COMMUNITY ENGAGEMENT FEEDBACK REPORT NOVEMBER 2020

PORT WILLUNGA NORTH COAST PARK

Appendix 1 – Port Willunga North Draft Concept Plan

Concept Plan Sheet 1 - Former Port Willunga Caravan Park site to Willunga Creek

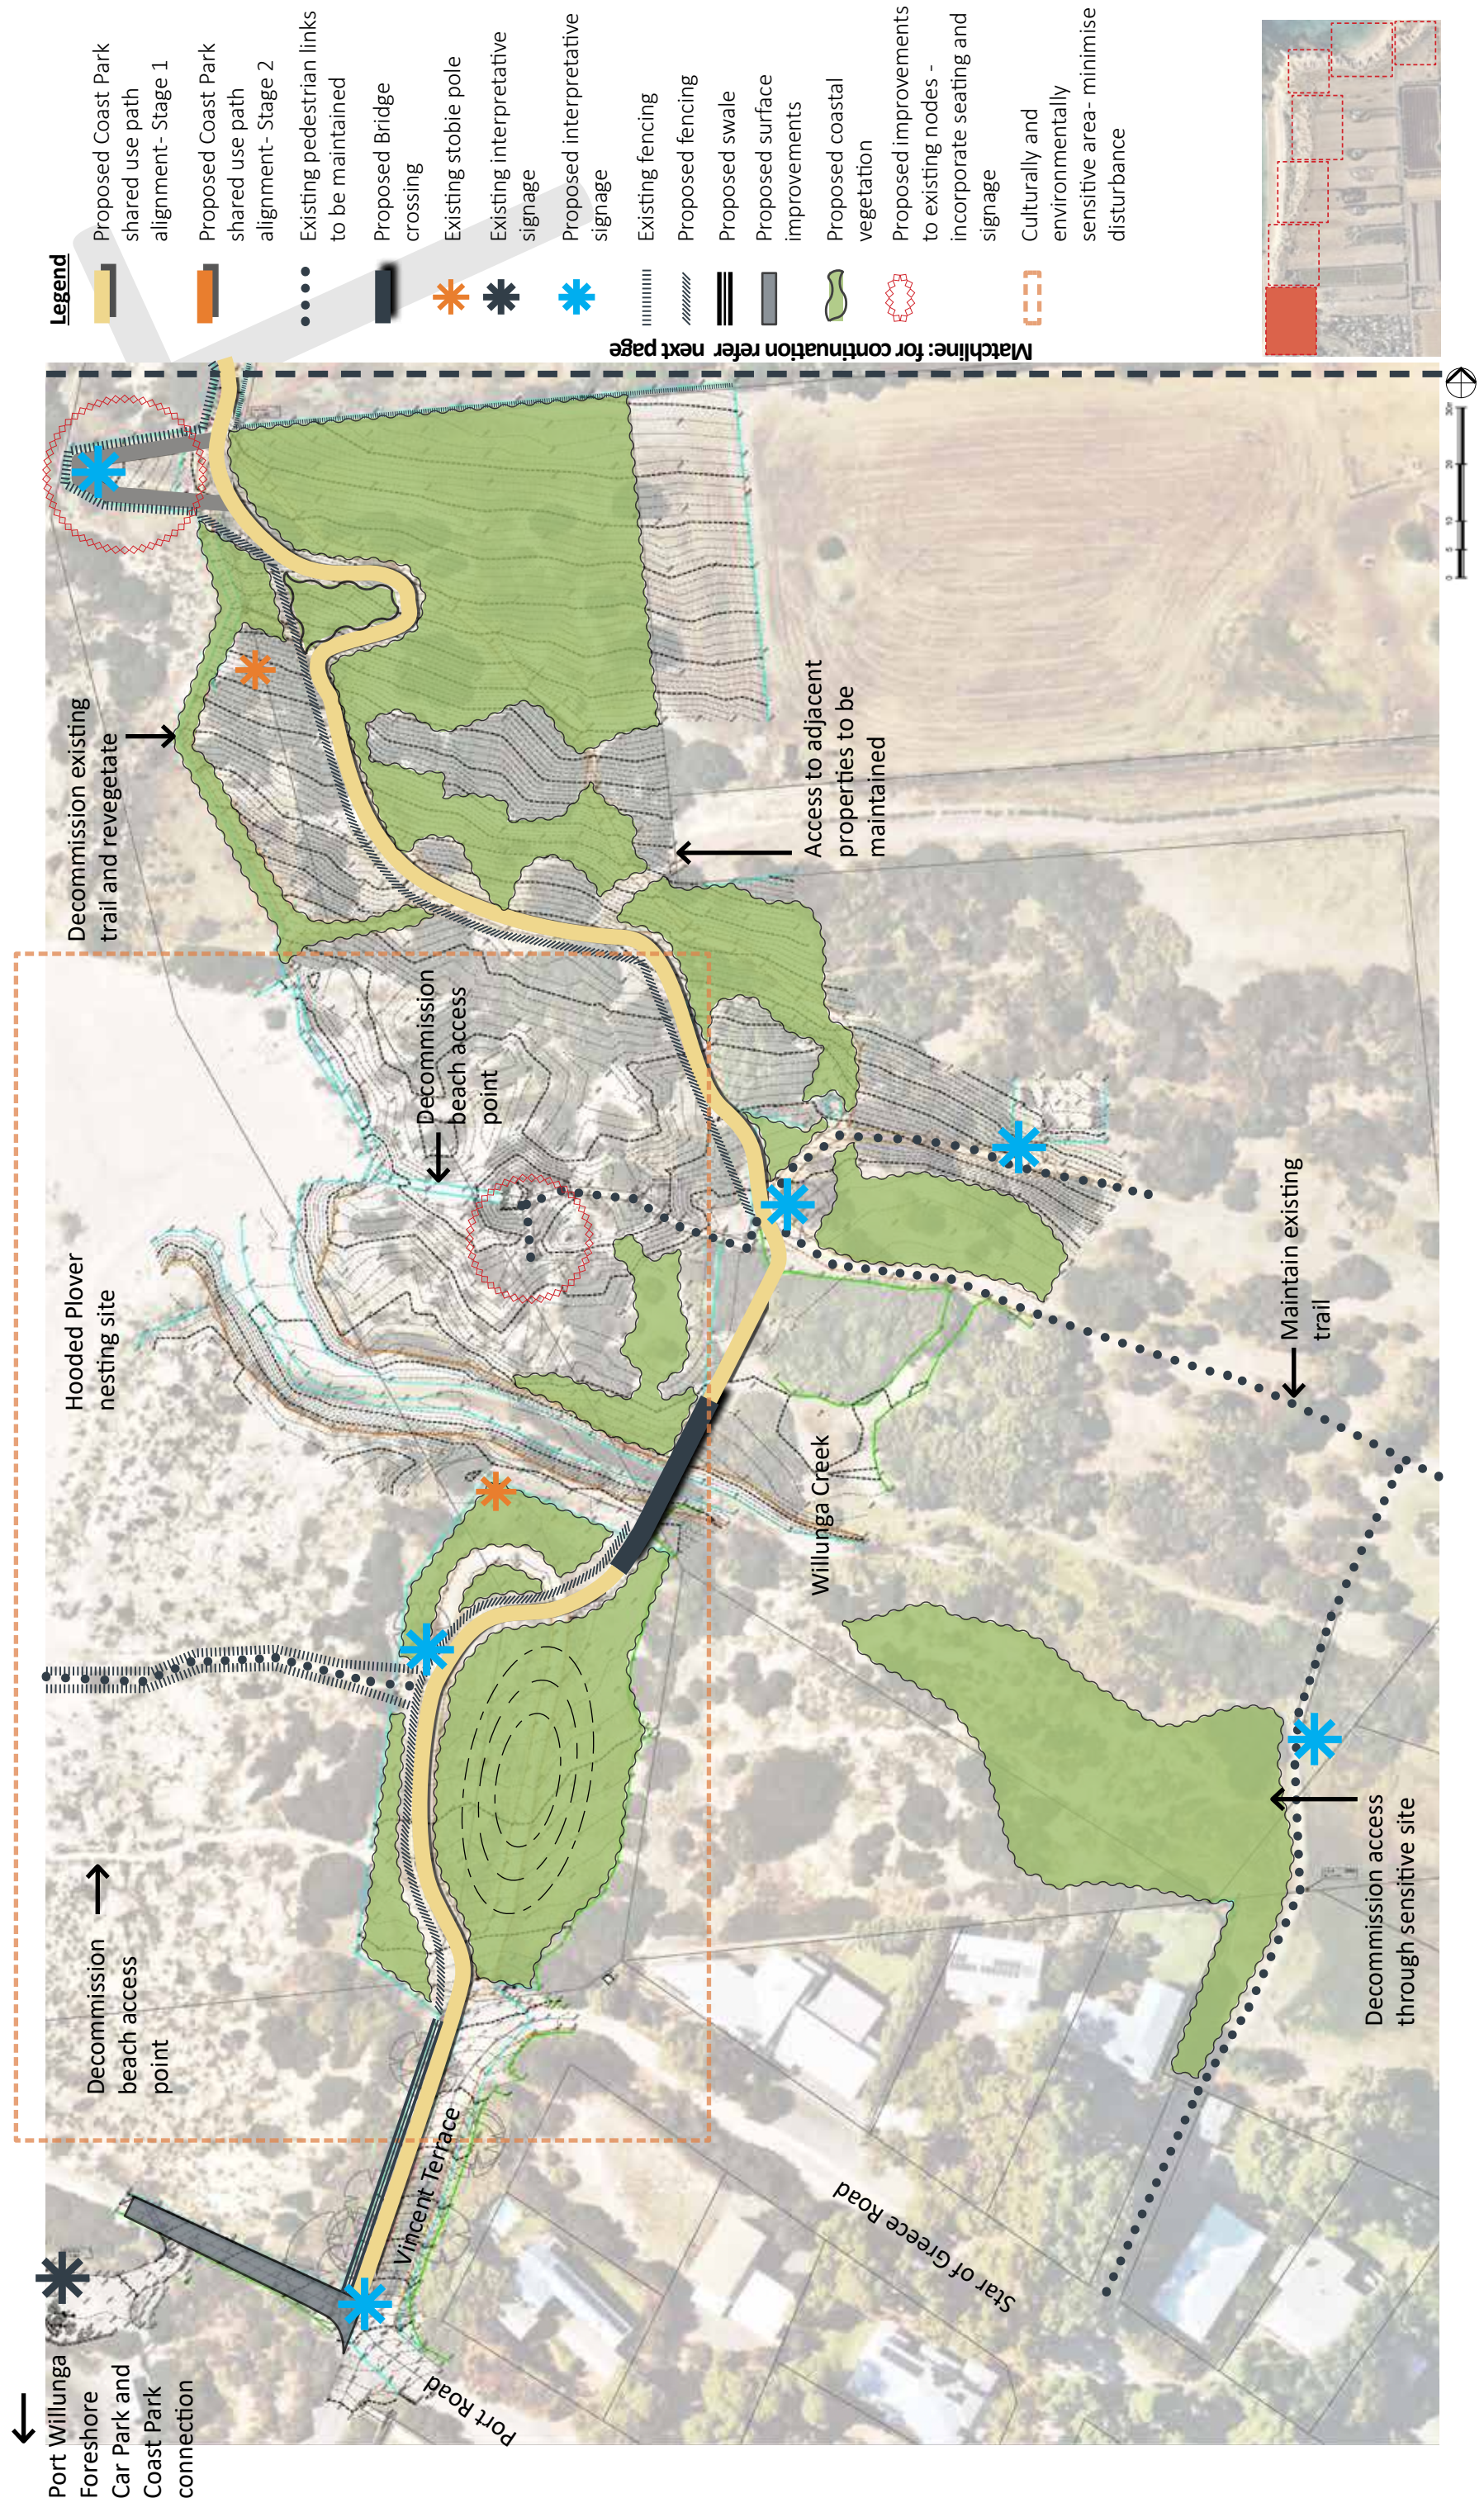
2744652	Do not support	Re: Concept Plan Sheet 1 - Former Port Willunga Caravan Park site to Willunga Creek. Recommend retaining the beach access just north of Willunga creek past the proposed "enhanced node" along the "to be maintained" track. Decommissioning this access beach disadvantages residents in Port Willunga North. This access point was a key decision point for us when we purchased the land.
2744801	Strongly Support	Excellent plan
2746647		All correspondence that you send out should say no motorbikes, they are having a problem with them in linear park and they are concerned about the path.
2746708	Neither support or do not support	It almost seems contradictory that we have a culturally and environmentally sensitive area in the Port Willunga Creek crossing area that is currently a safe, tranquil environment with an almost "secret garden" feel that will be lost forever by implementing this proposal and be potentially damaged by transients. I fail to understand how this benefits local rate paying residents who especially reside on the north side of the creek? In fact I put it you that it is detrimental to this area as many of us were sold on the special area that is the Creek crossing with it's secluded beach access. The link attached is a recent example (17 photos April 2020) how a block of land was marketed and sold demonstrating this very point. https://www.realestate.com.au/property/29-mindarie-st-port-willunga-sa-5173

Concept Plan Sheet 1 shows the old caravan park site (unlabelled) and the three existing trails through the sand dunes. The first is to be "decommissioned", the second retained, and the third (the boardwalk just north of the Willunga Creek) also decommissioned west of the seat "node".

Save this money, and use it to expedite the removal of the ghastly stobie poles (as shown on sheet 1). The one (?) household that is supplied by this connection should pay to have it re-supplied from Bowering Hill Rd. Why should rate-payers meet this cost?

- suggests further consideration of how the flexibility of retaining the current 3 x beach access points might be desirable before a decision is made to decommission the southern-most beach access point as on Concept Plan Sheet 1
- does not support perennial decommissioning of the beach access point to the north of creek
- supports retention of at least two beach access points, one south and one north of creek, with a mechanism (such as a lock and chain with explanatory signage) for temporary closure of either one or the other (or a retained third option) during HP breeding season (September 1 to December 31 inclusive)
- requests ongoing consultation on the details of beach access arrangements including the nature of fencing, gateways, signage and furniture

WBT Inc members are therefore concerned that even though Council has acknowledged the sensitivities of the area, (marked as '---culturally and environmentally sensitive area - minimise disturbance' on the Concept Plan Sheet 1), the proposal is to build a 3m wide sealed pathway and bridge for both cyclists and pedestrians straight through this area, including a bridge over the creek at the estuary and passing through a significant Aboriginal and European heritage site.

Concept Plan Sheet 2 - Willunga Creek to Chinaman Gully

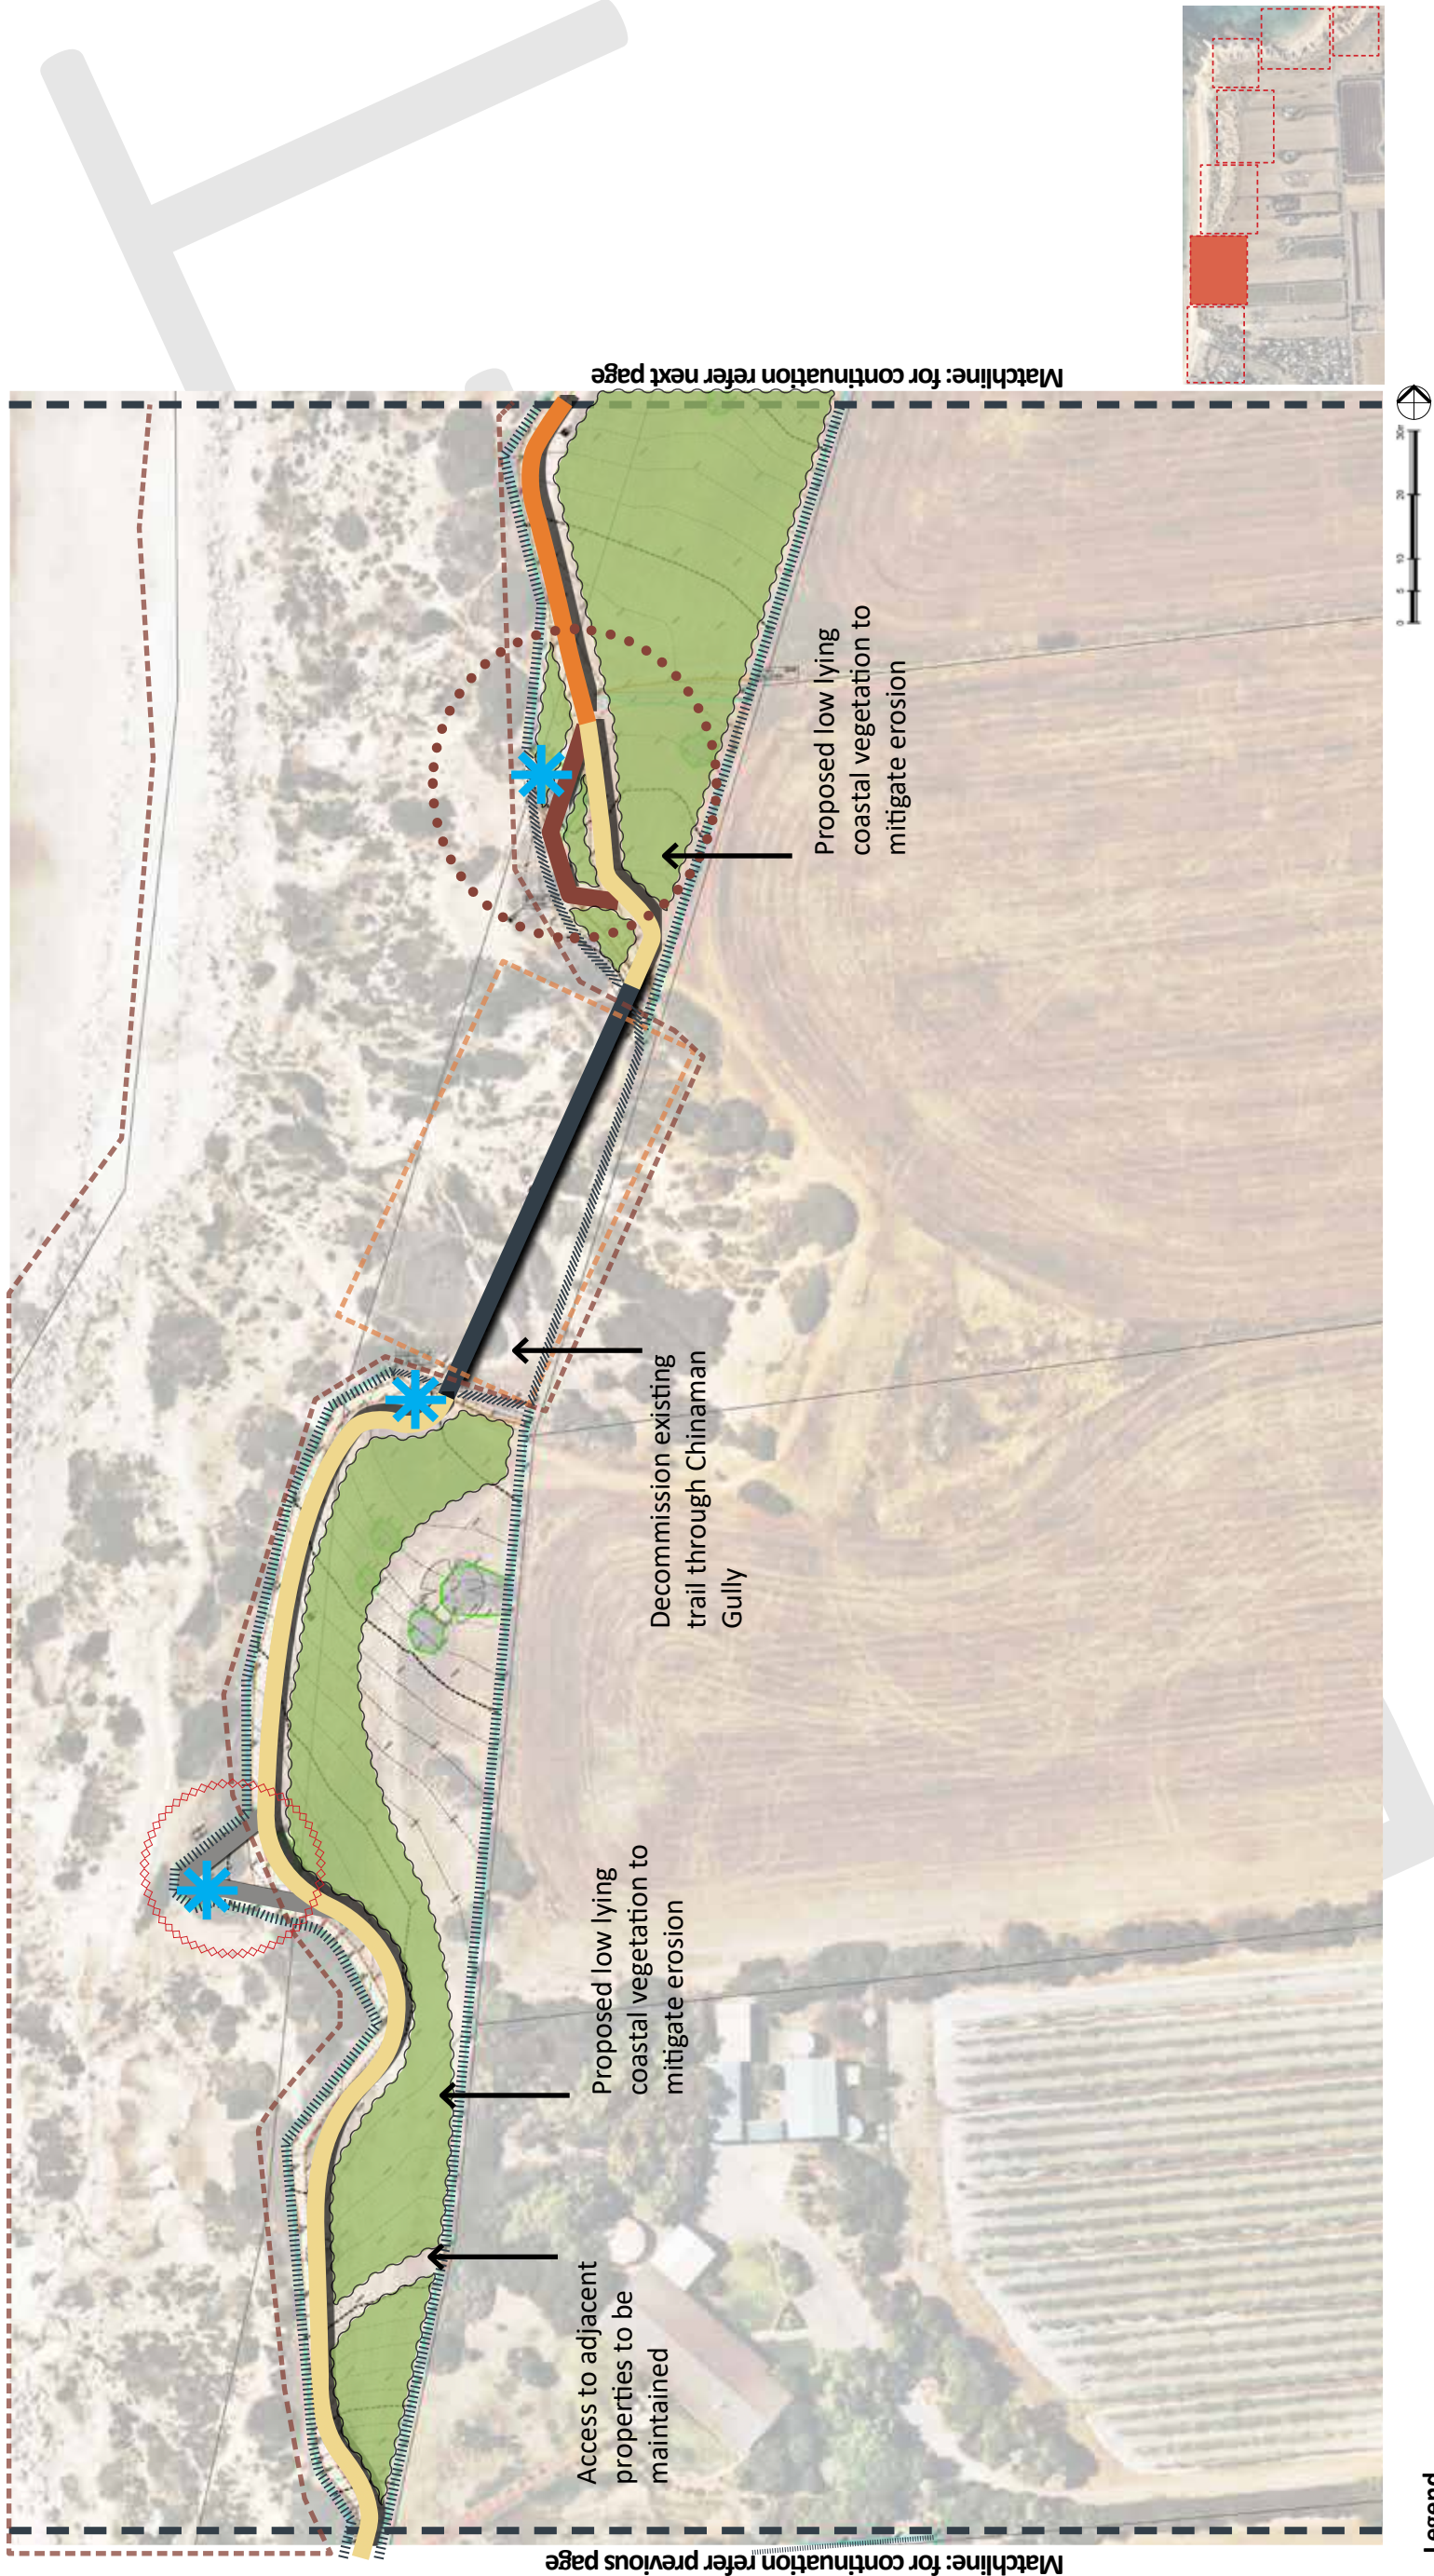
- Will the proposed bridge over Willunga Creek be designed to allow light through (mesh/grill design)?
- On sheet 2 of the concept plan it shows a proposed access path cutting through proposed coastal vegetation from a property adjacent to the track. This access path appears to be in the wrong place, as the house already has a path to the track without the need for an additional track (see PDF post its)
